#### **Addendum 128– UN Regulation No. 129**

#### **Revision 3 – Amendment 2**

03 series of amendments – Date of entry into force: 29 December 2018

#### **Uniform provisions concerning the approval of Enhanced Child Restraint Systems used on board of motor vehicles (ECRS)**

Figures of Strapped child

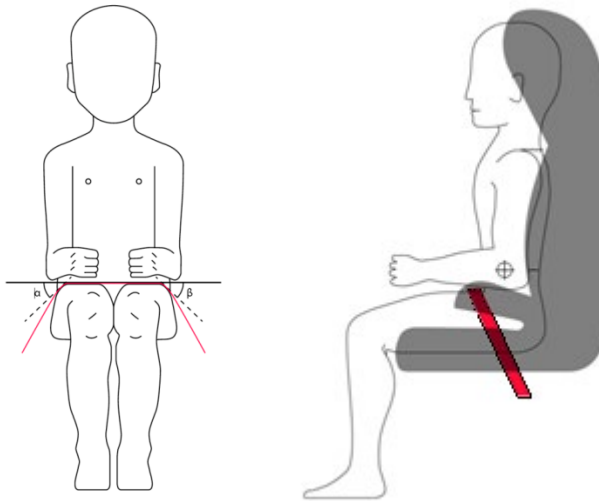
*Paragraph 6.2.1.5.*, amend to read:

In the case of booster seats, the lap portion of the adult safety-belt shall be positively guided on both sides to ensure that the loads transmitted by the adult lap belt are transmitted through the pelvis. The positive guidance of loads over the pelvis shall be realised from the moment that the child is installed; the lap belt shall pass over the top of the thigh, just touching the fold with the pelvis. The angles  $\alpha$  and  $\beta$  between the tangent line in which the belt touches the thighs and the horizontal shall be greater than 10°.

The shoulder portion of the adult safety belt shall be positively guided to ensure that the child torso and neck do not escape."

Figure 2  
Arrangement for testing a rearward-facing device, not supported by the dashboard

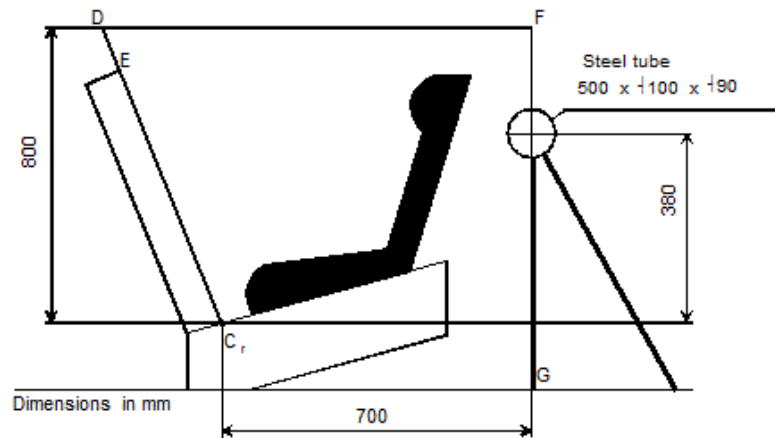
Paragraph 6.6.4.1.2.1., amend to read:

"6.6.4.1.2.1. Head excursion: no part of the head of the dummy shall pass beyond the planes FD, FG and DE, as shown in figure 2 below. This shall be judged up to 300 ms or the moment that the dummy has come to a definitive standstill whatever occurs first.

Except when testing using Q6 or Q3 dummy where the value in relation to the FD plane is 840 mm.

Where a test is conducted with paragraphs 6.6.4.1.6.1.1. or paragraph 6.6.4.1.6.1.2. or paragraph 6.6.4.1.8.2. above, only the second test results without 100 mm diameter bar will be considered.

Figure 4

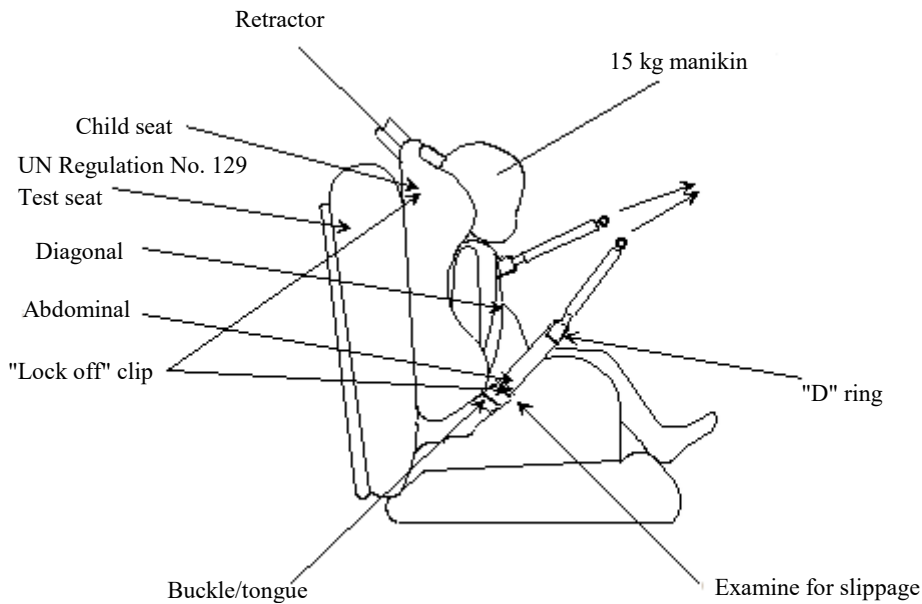
*Insert new paragraphs 7.2.9. to 7.2.9.2., to read:*

The Enhanced Child Restraint System and the largest manikin for which the Enhanced Child Restraint System is intended shall be set up as shown in Figure 4 below. The webbing used shall be as specified in Annex 23 to this Regulation. The lock-off shall be fully applied and a mark made on the belt where the belt enters the lock-off. The force gauges shall be attached to the belt via a D ring, and a force equal to twice ( $\pm 5$  per cent) the mass of the heaviest dummy for the size range shall be applied for at least one second. The lower position shall be used for lock-offs in position A and the upper position for lock-offs in position B. The force shall be applied for a further nine times. A further mark shall be made on the belt where it enters the lock-off and the distance between the two marks shall be measured. During this test, the retractor shall be unlocked.

## "Annex 2

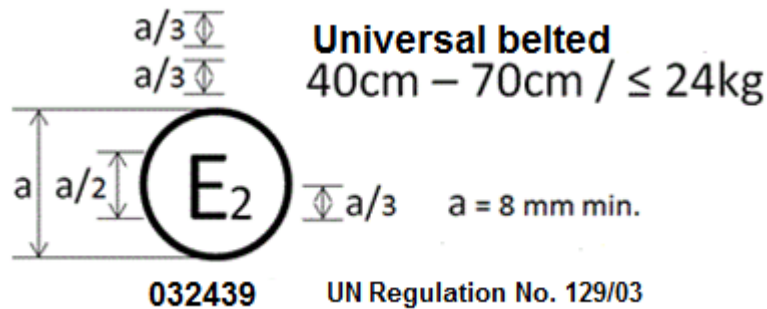
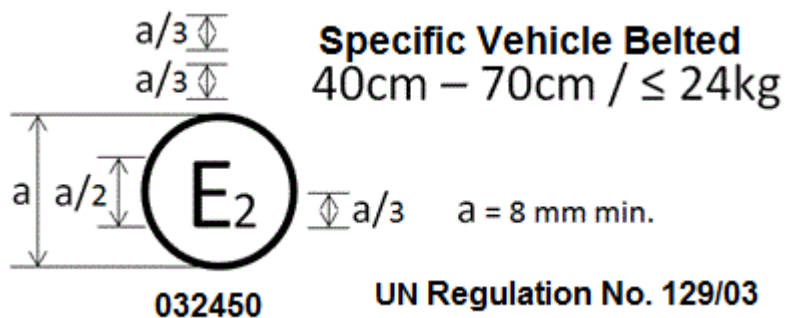
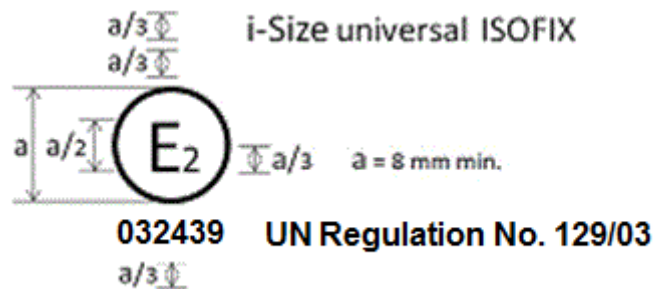
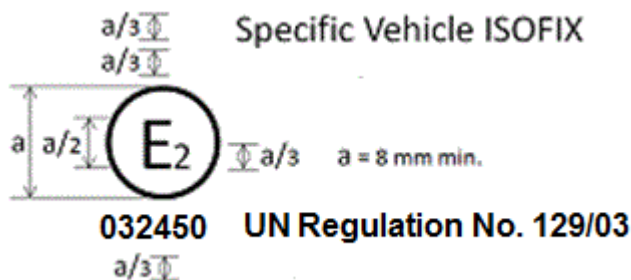
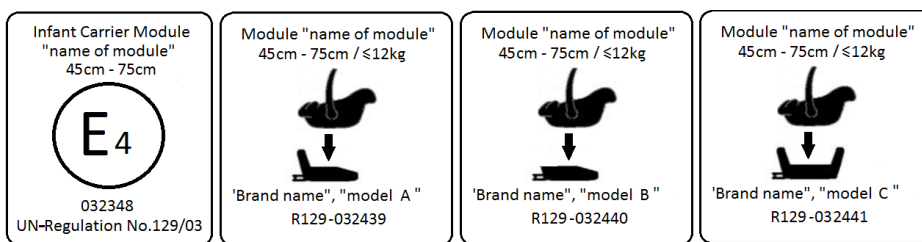
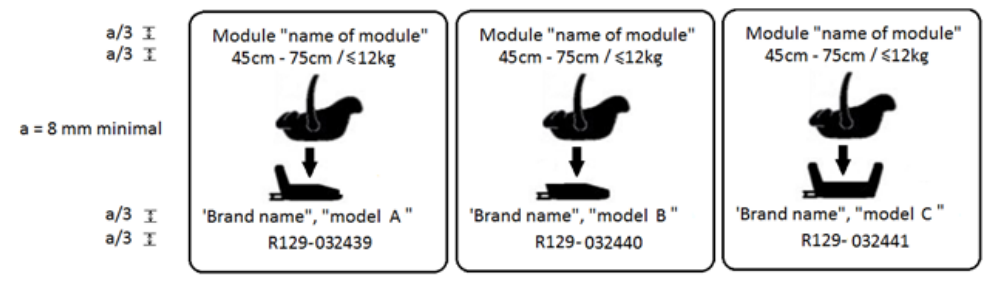
Annex 2, amend to read:

The Enhanced Child Restraint System bearing the above approval mark is a device capable of being fitted in any universal seating position of the vehicle and of being used for the 40 cm - 70 cm size range; it is approved in France (E 2) under the number 032439. The approval number indicates that the approval was granted in accordance with the requirements of the UN Regulation on approval of Universal Belted Enhanced Child Restraint Systems used on-board of motor vehicles as amended by the 03 series of amendments. In addition the name of the UN Regulation must be identified on the approval mark followed by the series of amendment according to which the approval has been granted.

The Enhanced Child Restraint System bearing the above approval mark is a device not capable of being fitted in every vehicle and capable of being used for the 40 cm - 70 cm size range; it is approved in France (E 2) under the number 032450. The approval number indicates that the approval was granted in accordance with the requirements of the UN

The Enhanced Child Restraint System bearing the above approval mark is a device, including module(s), capable of being fitted in any i-size compatible vehicle seating position. It is approved in France (E 2) under the number 032439. The approval number indicates that the approval was granted in accordance with the requirements of the UN Regulation concerning the approval of Enhanced Child Restraint Systems used on-board of motor vehicles as amended by the 03 series of amendments. In addition the name of the UN Regulation has to be identified on the approval mark followed by the series of amendment according to which the approval has been granted.

The Enhanced Child Restraint System bearing the above approval mark is a device, including module(s), not capable of being fitted in every vehicle. It is approved in France (E 2) under the number 032450. The approval number indicates that the approval was granted in accordance with the requirements of the UN Regulation concerning the approval of Specific vehicle ISOFIX Enhanced Child Restraint Systems used on-board of motor vehicles as amended by the 03 series of amendments. In addition the name of the UN Regulation has to be identified on the approval mark followed by the series of amendment according to which the approval has been granted.

2.1.1. Where a module is approved for use with more than one base, the individual base and module combinations shall be indicated on the module in separate module marks, each bearing their applicable size ranges.

Annex 5, Figures 1 and 2, amend to read:

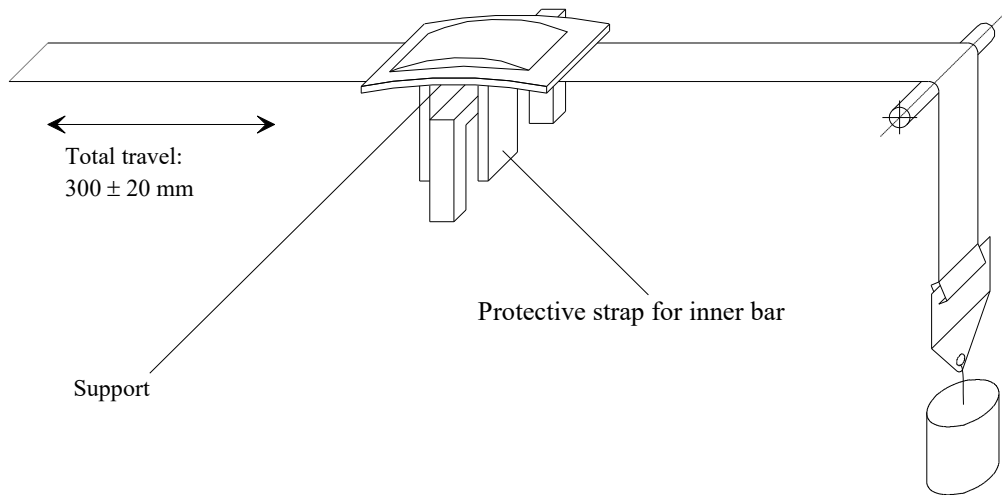
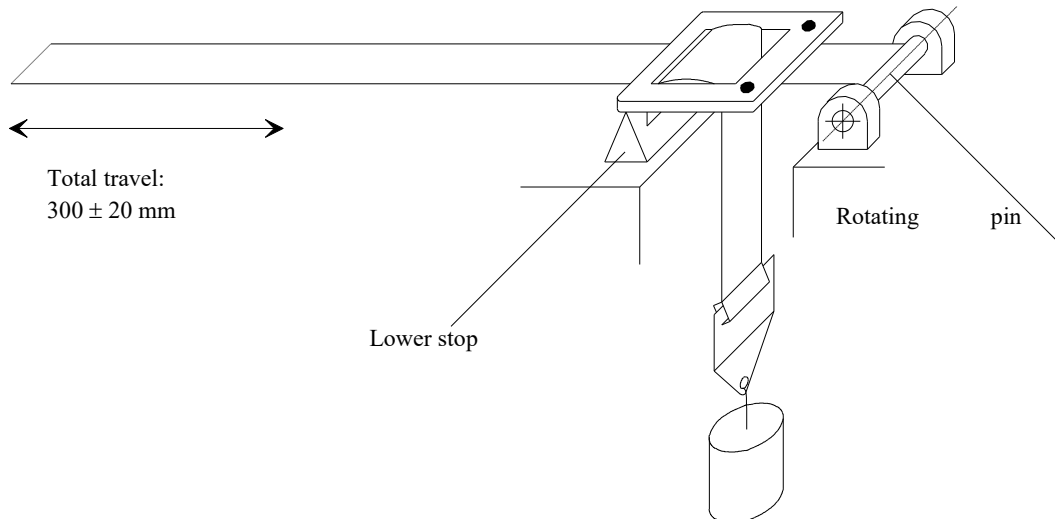
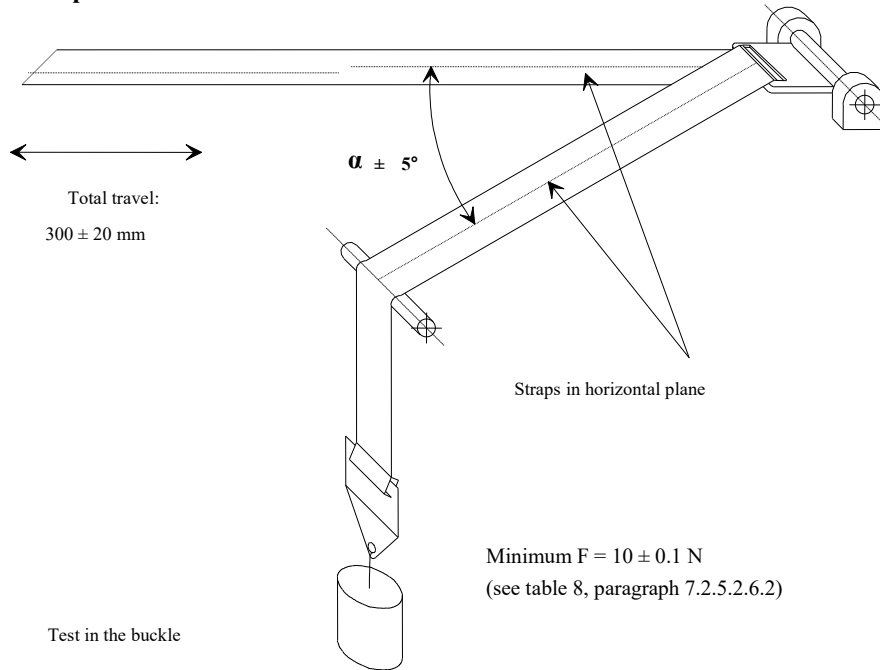
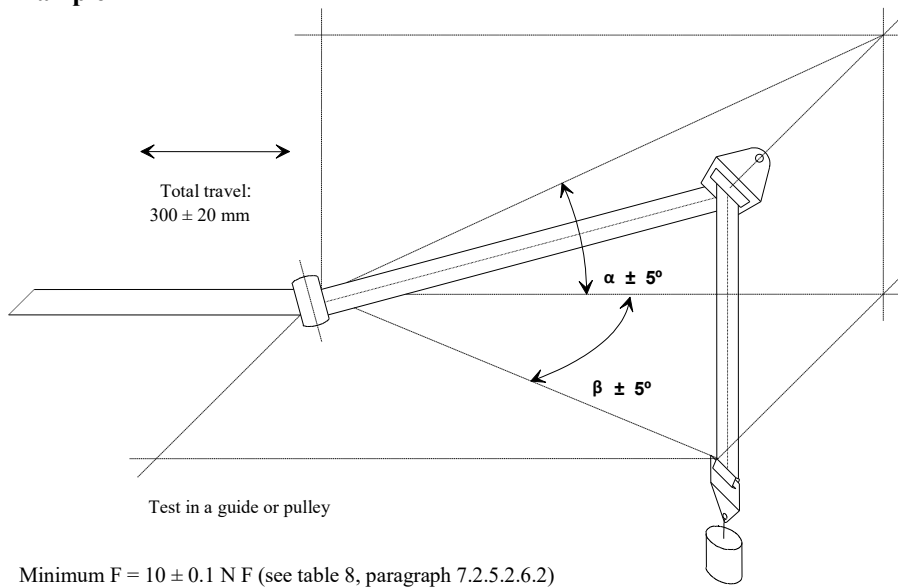
Figure 1  
Procedure type 1

$F = 10 \pm 0.1$  N, can be increased up to maximum  $F = 60 \pm 0.5$  N (see table 8, paragraph 7.2.5.2.6.2.)

Figure 2  
Procedure type 2  
Following two examples of test set up

Where  $\alpha$  and  $\beta$  reproduce the angles as in the real installation (in three dimensions)  
..."

"Figure 5

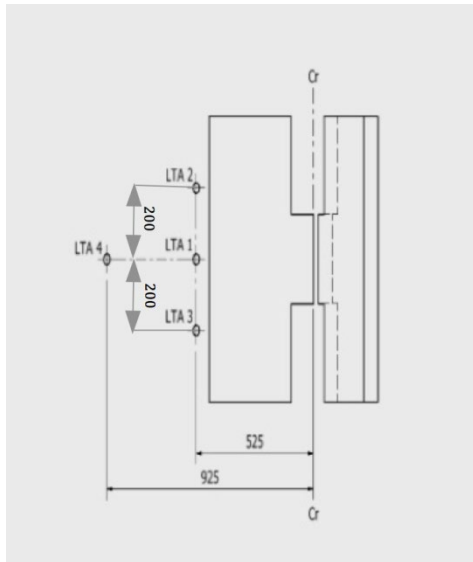
Appendix 2, insert new figure 5:

**Lower strap anchorages (LSA 1, LSA 2, LSA 3 and LSA 4)**

Figure 3

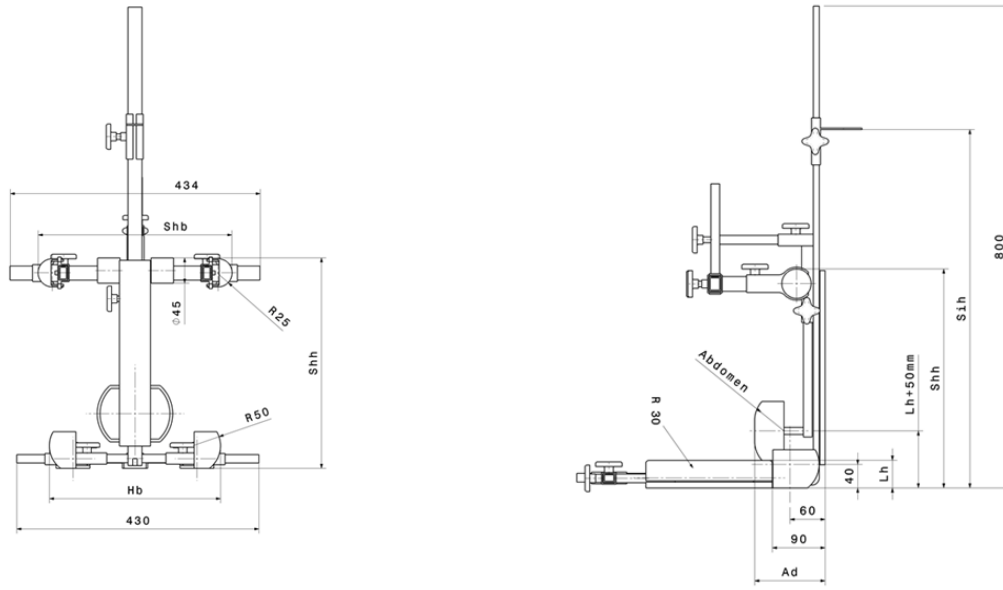
*Annex 18, amend to read:*

**Side and Front View of the measuring device for measurements applicable to Enhanced Child Restraint Systems that feature an impact shield**
